**U.S. DEPARTMENT OF ENERGY (DOE) RESPONSES TO COMMENTS IN THE STATE OF NEVADA'S
MAY 30, 1989, LETTER ON THE EXPLORATORY SHAFT FACILITY (ESF)**

RESPONSES TO STATE OF NEVADA LETTER ON THE SITE CHARACTERIZATION PLAN/ EXPLORATORY SHAFT FACILITY

U.S DEPARTMENT OF ENERGY'S COMMENT RESPONSES FOR THE PRELIMINARY
COMMENTS RECEIVED FROM THE STATE OF NEVADA

Figure 1. Inferred faults in the Coyote Wash area as interpreted by Smith and Ross (1982).

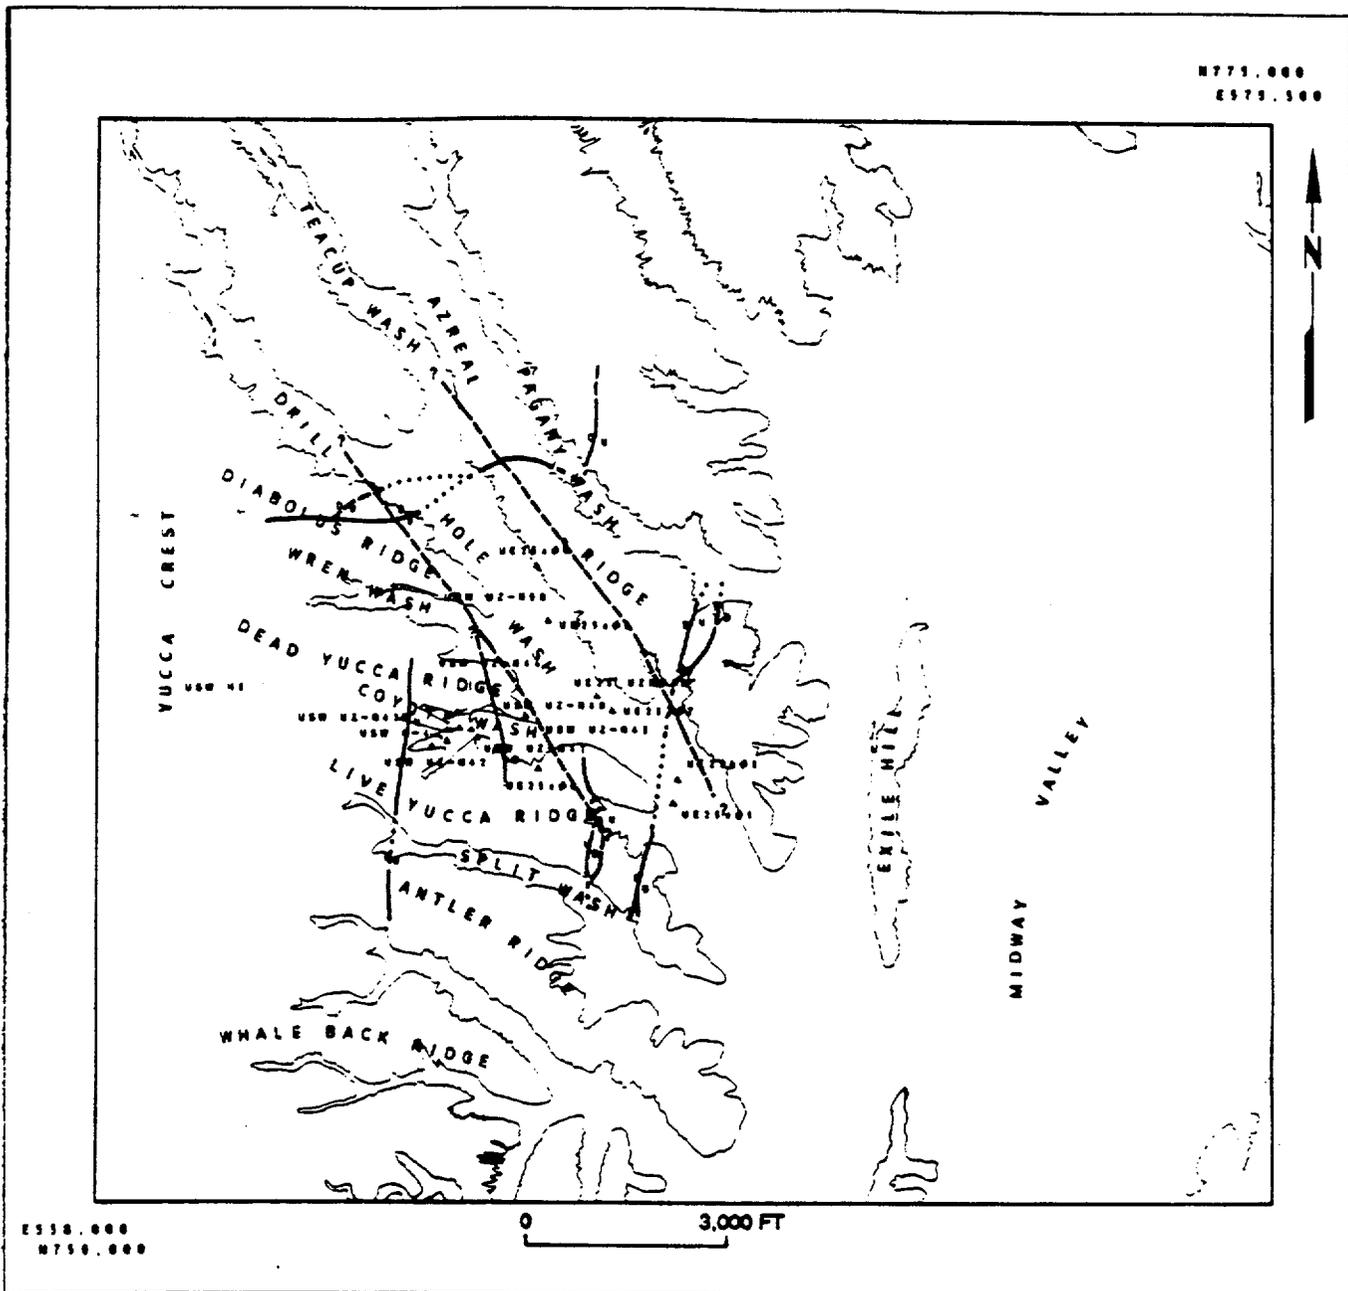
In addition to the fault/fracture zone inferred in Drill Hole Wash, Smith and Ross (1982) inferred the presence of a minor normal fault in Coyote Wash (Figure 1). This inferred fault was located about 400 meters (1,300 feet) east of Ghost Dance fault and was inferred to be downthrown to the east.

Figure 2. Faults interpreted from resistivity data by Hoover, mapped faults shown by Lipman and McKay (1965), locations of resistivity lines.

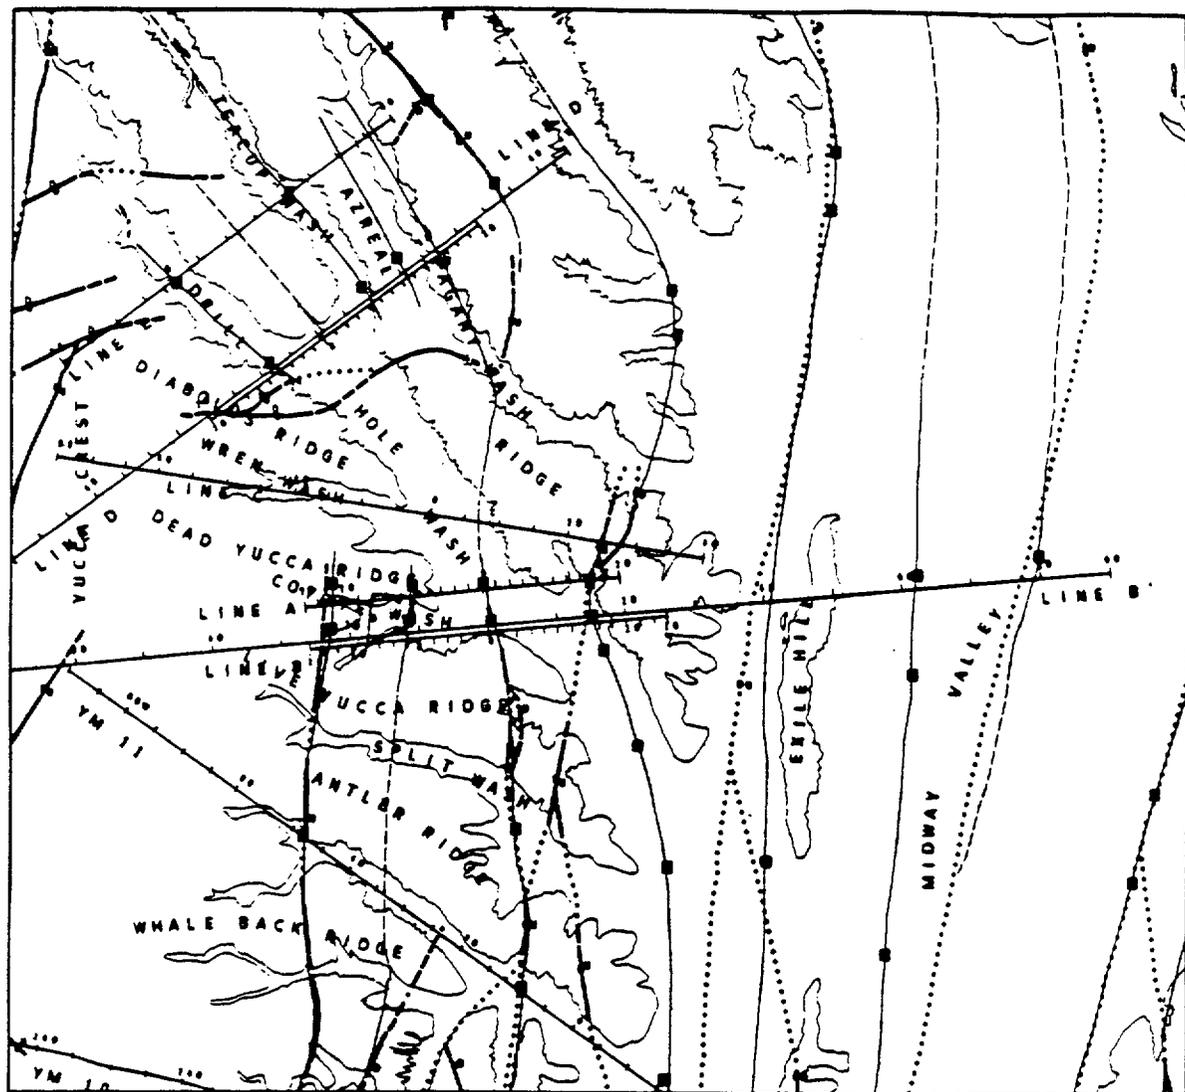
The Open File Report figure is apparently based on an unpublished interpretive map of published and unpublished electrical resistivity data compiled by D.B. Hoover. This unpublished map indicates that the location of the northern end of this longer fault cutting Coyote Wash is based on the interpretation of Smith and Ross (1982). Hoover used a dashed line to connect the inferred fault in Coyote Wash with another fault inferred to cross unpublished resistivity line YM10 at a point about 7,500 ft south of

Coyote Wash (Figure 2). The location of the inferred fault cutting line YM10 coincides with a fault mapped by Lipman and McKay (1965), which trends to the northeast of the hypothesized connection between the inferred resistivity faults and terminates near Whale Back Ridge (Figure 2). However, in the figure that appears in the Open File Report (USGS 1984) and the SCP, the dashed line connecting the two inferred fault segments has been replaced by a solid line (Figure 3). This appears to represent a drafting error in the preparation of the published figure since other dashed lines shown on the unpublished version of the map were generally deleted from the published map.

Figure 3. Faults interpreted from electrical resistivity data as shown on Figure 32 of U. S. Geological Survey Open File Report 84-792 and in SCP Figure 1-40.

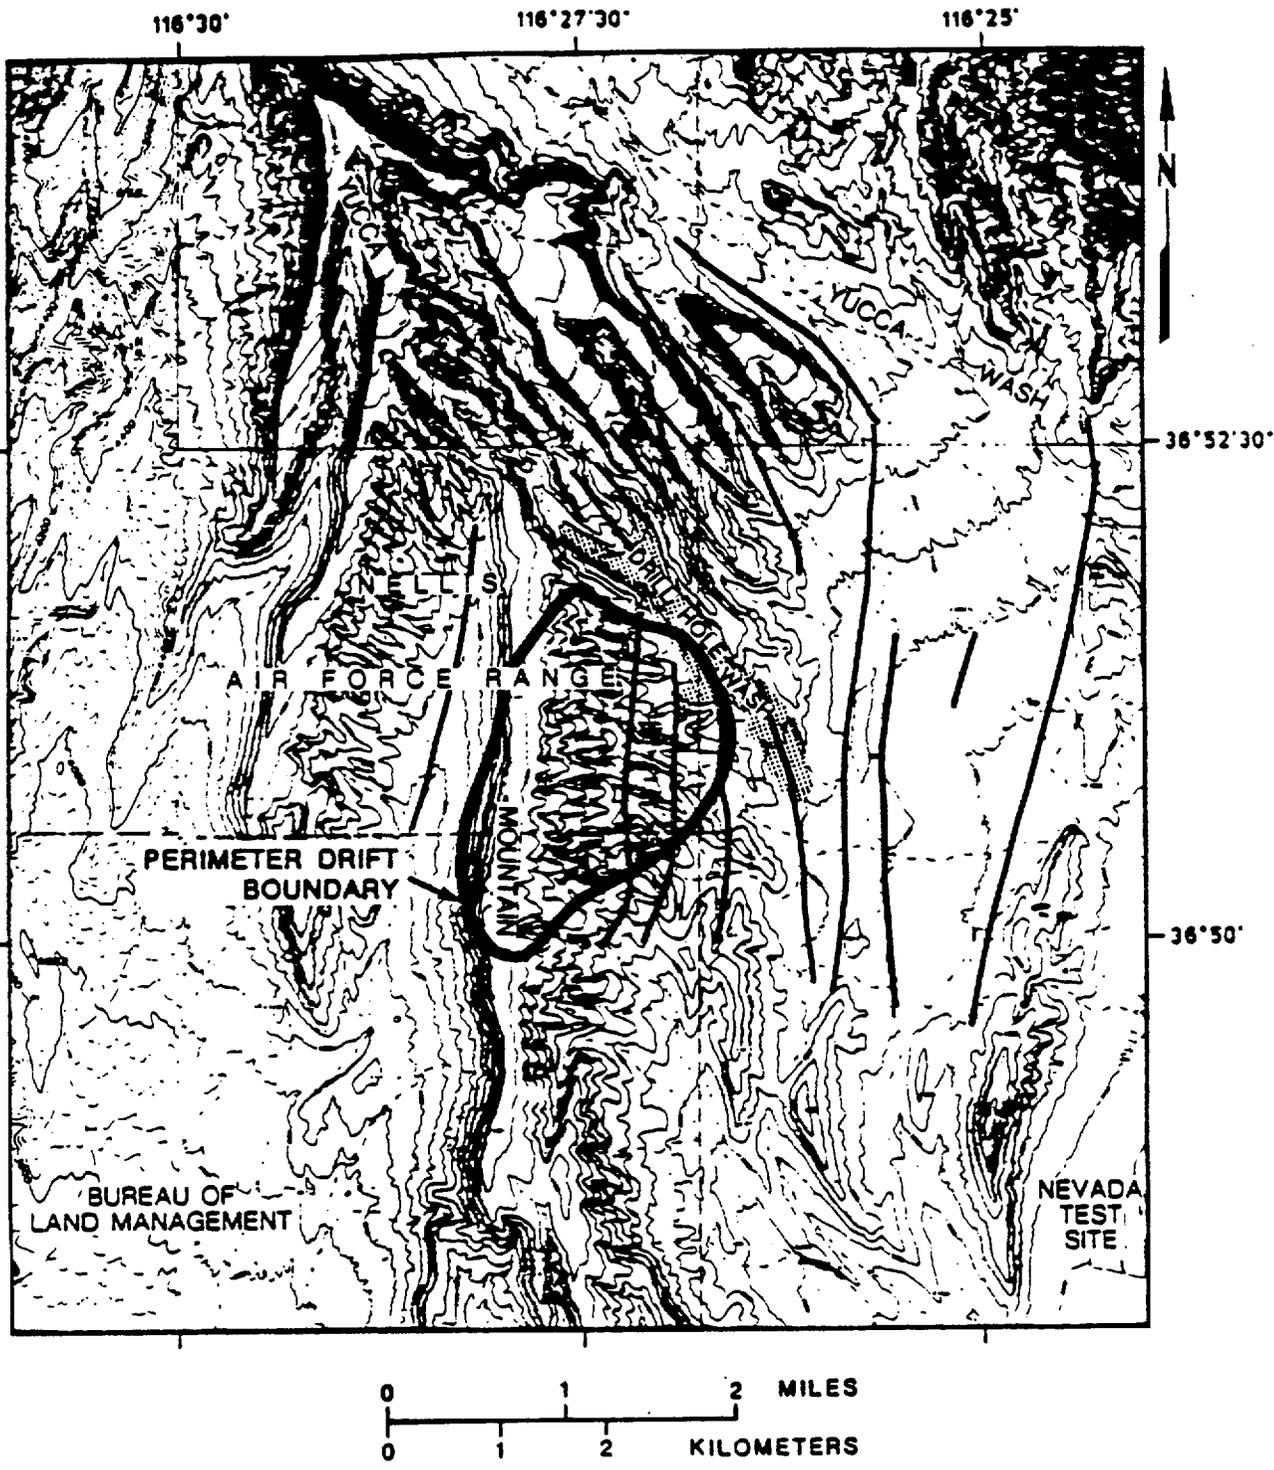
USGS Open File Report 84-792 (USGS, 1984) is a compilation and interpretation of geologic data on the Yucca Mountain region acquired before January 1, 1983. The report was used as a source in the preparation of the geologic descriptions of Yucca Mountain for the Environmental Assessment (EA) (DOE, 1986) and the Site Characterization Plan (SCP). Figure 32 of the Open File Report shows a map of "Faults and (or) fractures at Yucca Mountain interpreted from electrical resistivity data." The text of the Open File Report does not give any additional information on the source of this interpretation. The same figure was also duplicated in the SCP as Figure 1-40. This figure shows a fault in Coyote Wash at the location where a fault was inferred by Smith and Ross (1982), but also shows the fault extending much farther to the south than Smith and Ross indicated.

Figure 4. Location of faults shown by Scott and Bonk (1984) and siting area and shaft locations recommended by Bertram (1984).

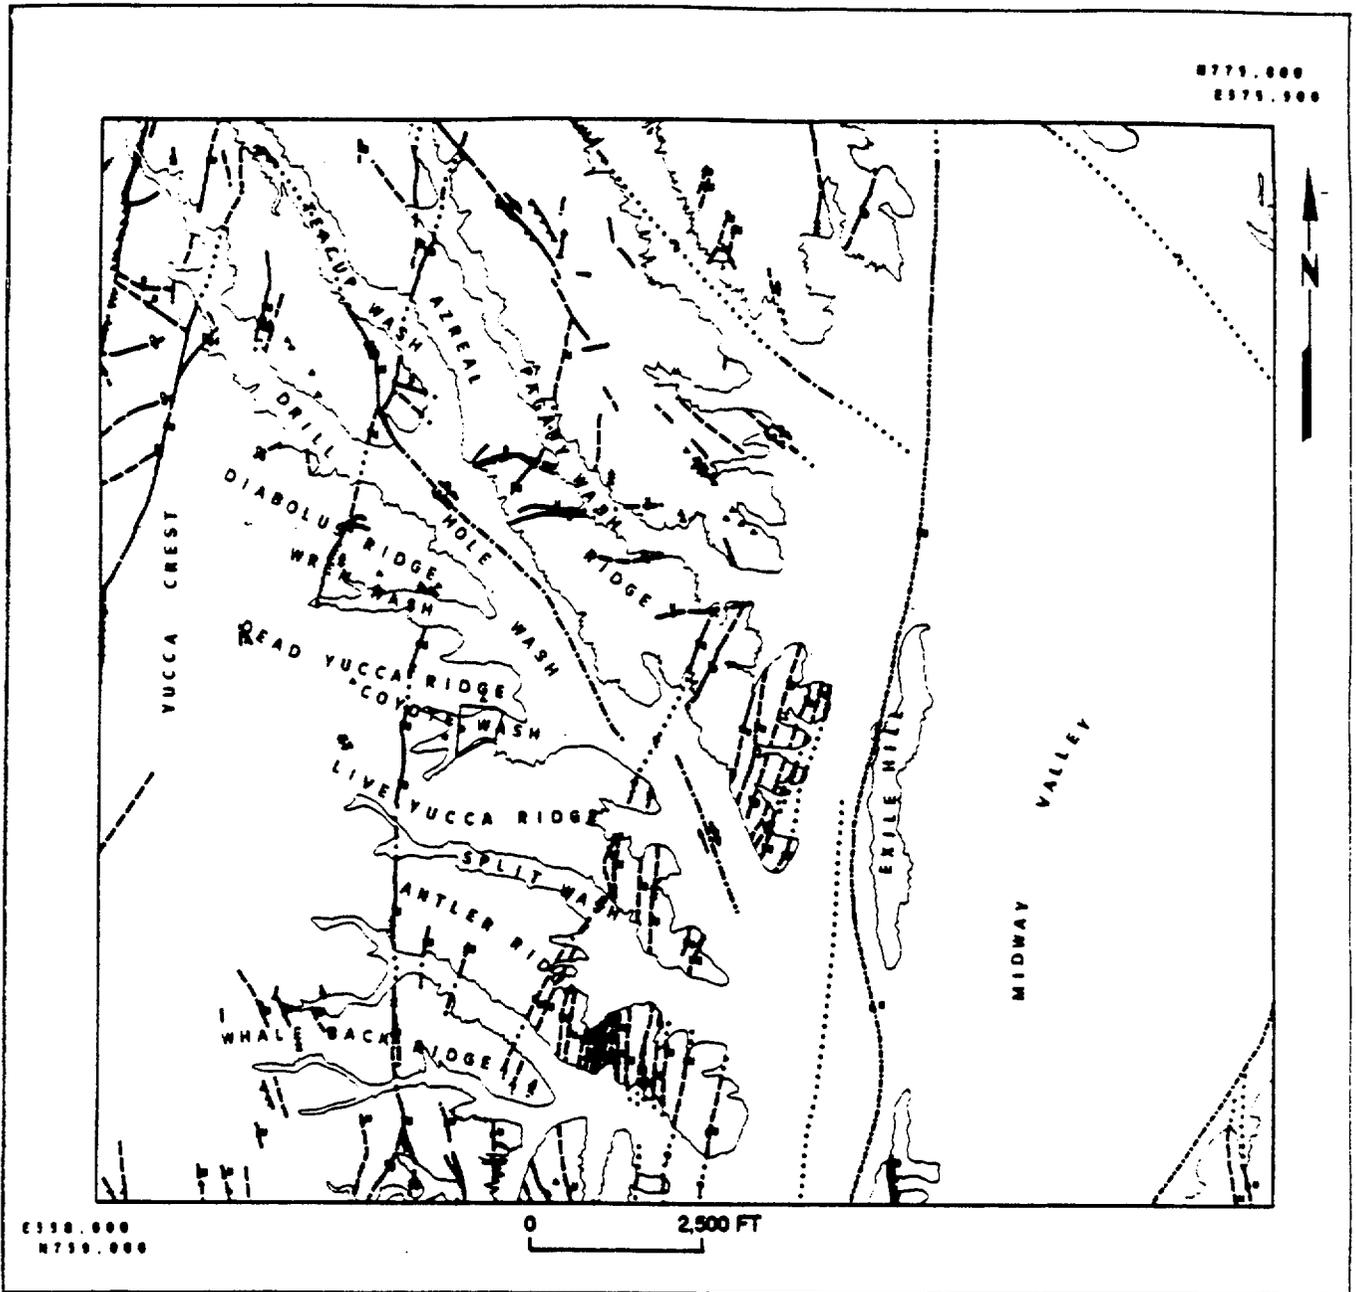
A map identifying potentially adverse structures was prepared using a preliminary version of the Scott and Bonk (1984) map as a source (Spengler, oral communication). The only potentially adverse structure identified on this map in the Coyote Wash area was the Ghost Dance fault (Figure 4). One Ad Hoc TOC committee member was aware of the report by Smith and Ross, but was of the opinion that the Scott and Bonk mapping was more reliable because topographic effects may have affected the resistivity/IP survey and the interpretation of Smith and Ross was not confirmed by the drilling program in Drill Hole Wash. Also, the main concern at the time was to identify significant throughgoing structures; apparently minor features, such as the fault inferred by Smith and Ross (1982) in Coyote Wash, were not considered in shaft selection because they had no mapped extent. Therefore, the faults shown in the Smith and Ross (1982) report in Coyote Wash were not considered to be potentially adverse structures.

Figure 1-40. Faults and fractures at Yucca Mountain interpreted from electrical resistivity data. Stippling shows zone of inferred fracturing and faulting along Drill Hole Wash; fault trends appear to change abruptly across this zone. Modified from USGS (1984).

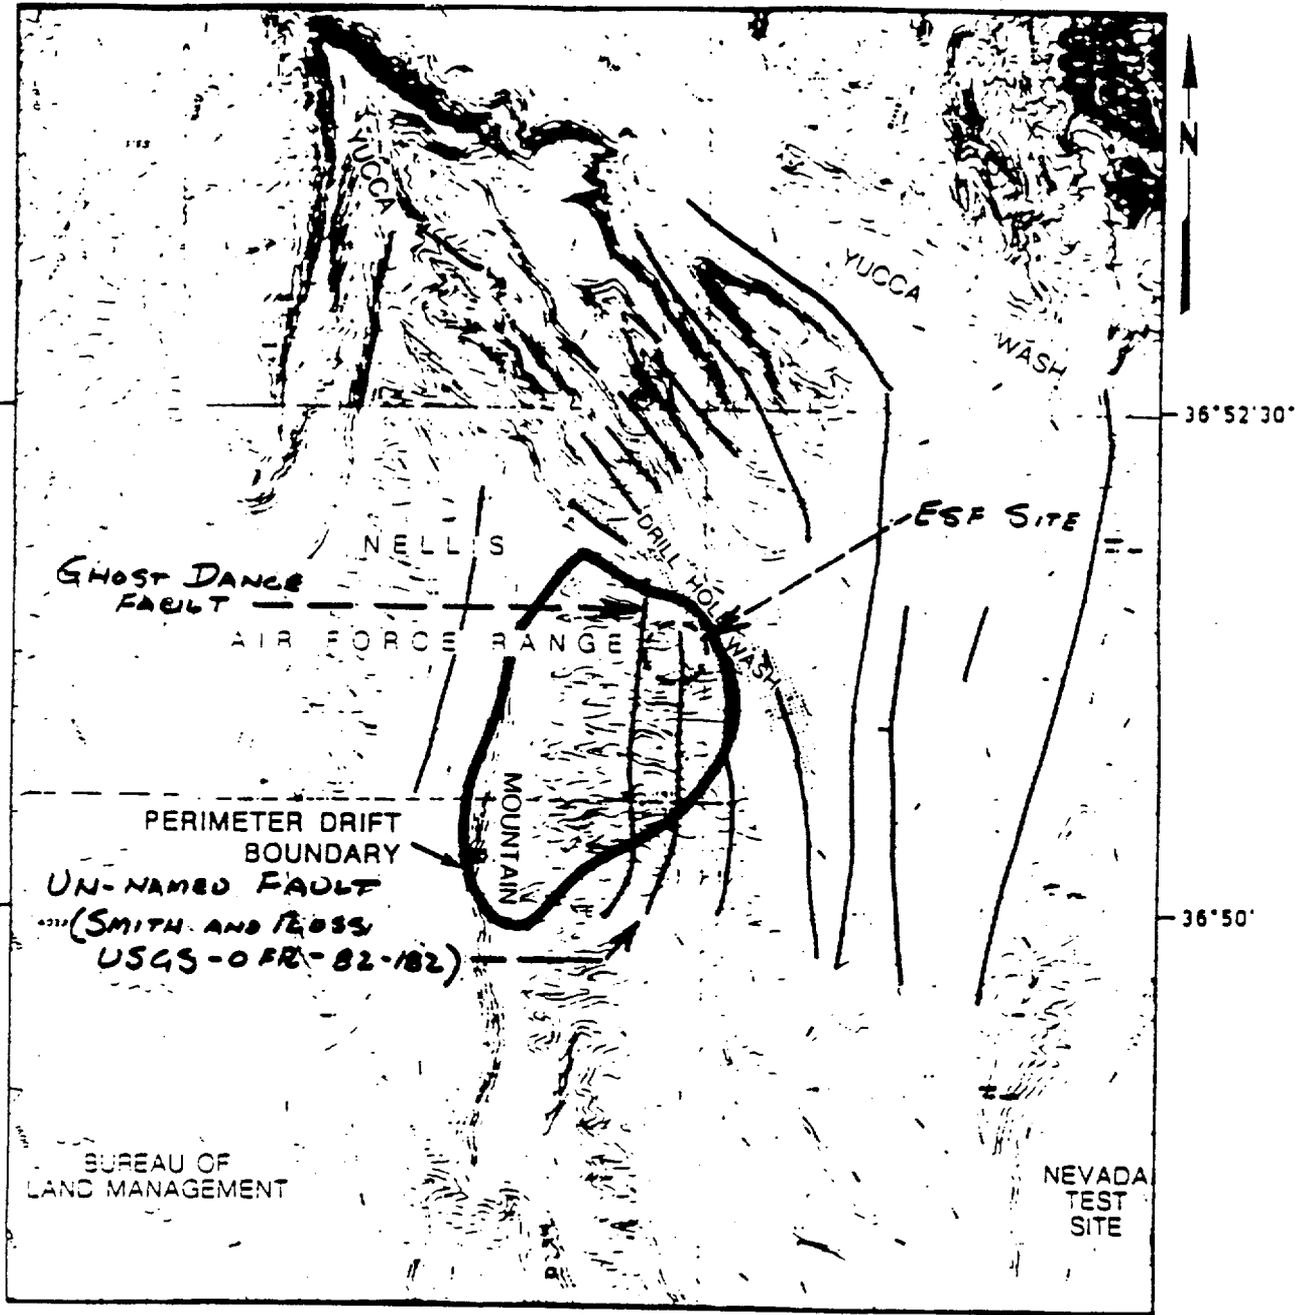
The Design Acceptability Analysis (DAA) did not evaluate the currently proposed location for the ESF in relation to a postulated "resistivity fault" (Smith and Ross, 1982), since (1) the anomaly is not unambiguously recognizable as a fault due to lack of surface expression, (2) there exists the possibility of alternative explanations for the origin of the resistivity anomaly, and (3) even if the DAA did assume a fault, it is not a through-going structure of significant mappable extent that could be considered a "potentially adverse condition". See also the response to Comment 2, and the Technical Assessment Review, "Geologic and Geophysical Evidence Pertaining to Structural Geology in the Vicinity of the Proposed Exploratory Shaft" (DOE, 1990).
